CITY OF ST. CHARLES ILLINOIS • 1834	**HISTORIC PRESERVATION COMMISSION AGENDA ITEM EXECUTIVE SUMMARY**			
	Agenda Item Title/Address:	COA: 1 E Main St		
	Significance:	Significant		
	Petitioner:	Conrad Hurst		
	Project Type:	Façade Work		
	PUBLIC HEARING		**MEETING 2/3/21**	**X**

- Applicant has provided revised plans for the proposed façade renovation based on the Commission's Comments from the previous two meetings.

Address of Property: 1 E. MAIN STREET

FACADE IMPROVEMENT AIMED AT BEAUTIFYING DOWNTOWN CBD 2 / MAIN STREET CORRIDOR, GUIDED BY FUNCTIONALITY OF PLANNED END USERS WHILE HONORING SHAPE & STRUCTURE OF EXISTING

2 PROPOSED NORTH ELEVATION - FRONT PATIO
1/4" = 1'-0"
0 1' 2' 4' 8'

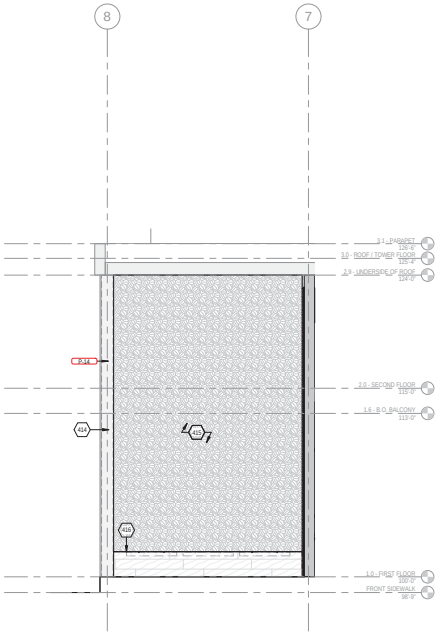
2) The architects are proposing cutting fenestration into the facades that are highly insensitive and uncreative; and to boot, are adding surface treatments and secondary elements of wood that are completely out of character. These changes will alter and ultimately permanently destroy the integrity of the modernist building. This loss will be permanent and an important site in St Charles (who have the opportunity to show-case a progressive adaptive re-use of a site) will in future not reflect well on the preservation commission's work.

The proposed façade changes to the Harris Bank building **severely detract from the original design of the building**. Though it appears that an attempt was made by the design team to mimic the alternating vertical bands of glass and brick that characterize the west elevation and portions of the south elevation, the resulting fragmentation complicates a historically simple façade design. Proposed louvered screens add further visual noise to the riverside elevation and the addition of a projecting one-story vestibule at the north, main elevation significantly alters the overall massing of the original design.
